# Access Compliance Report

## Public Rights-of-Way

### (Curb Ramps)

Intersection ID: 46188	Main Street: SEVEN_OAKS_DR	Cross Street: YAUPON_RD	Location: SW
ADA ID: 890C343CD926	Ramp Type: PerpDiag	Initial Pass/Fail: Fail	Overall Compliance: No
Severity Score: 12.5			
Codes/Mitigation Info/Possible Solution		Field Measurements/Component Compliance

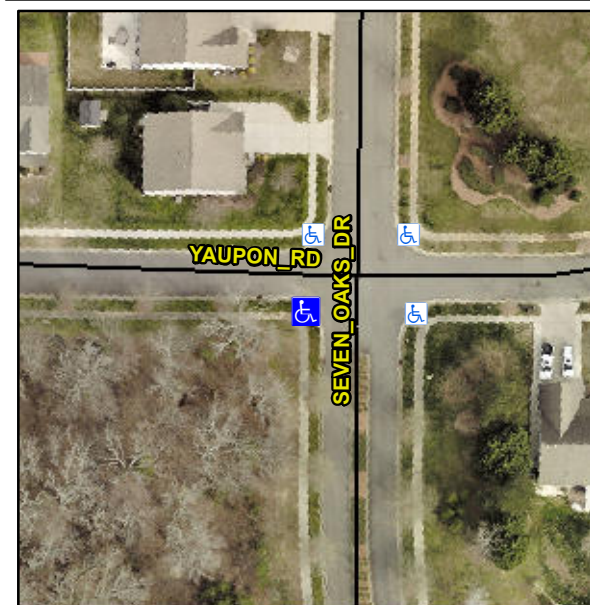
**Not Found, R304.2.2**

Compliance	Description	Data	Compliance	Description	Data
N/A	Ramp Length (in)	72.5	No	Ramp Slope (%)	9.1
Yes	Ramp Width (in)	48.0	Yes	Ramp XSlope (%)	0.7
N/A	Flare Type LT	N/A	N/A	Flare Type RT	N/A
N/A	Flare Slope LT (%)	N/A	N/A	Flare Slope RT (%)	N/A
N/A	Flare Traversable LT?	N/A	N/A	Flare Traversable RT?	N/A
N/A	Landing Length (in)	N/A	N/A	DWS Provided?	N/A
N/A	Landing Width (in)	N/A	N/A	DWS Contrast?	N/A
N/A	Landing Slope (%)	N/A	N/A	DWS Length (in)	N/A
N/A	Landing X Slope (%)	N/A	N/A	DWS Full Width?	N/A
N/A	Landing Curb? (Y/N)	N/A	N/A	DWS Offset (in)	N/A
N/A	Shared Landing?	N/A			
N/A	Gutter Ponding?	N/A	N/A	Gutter Slope (%)	N/A
N/A	Gutter Lip Ht (in)	1.0	N/A	Gutter X Slope (%)	N/A
N/A	Painted X Walk1?	No	N/A	Painted X Walk2?	No
	X Walk 1 Direction	To SE		X Walk 2 Direction	To N
N/A	X Walk 1 Width (in)	N/A	N/A	X Walk 2 Width (in)	N/A
	X Walk 1 Slope (%)	3.0		X Walk 2 Slope (%)	0.2
	X Walk 1 X Slope (%)	1.8		X Walk 2 X Slope (%)	1.4

**Remove & Replace Curb Ramp With Two New Directional Ramps or Equivalent.**
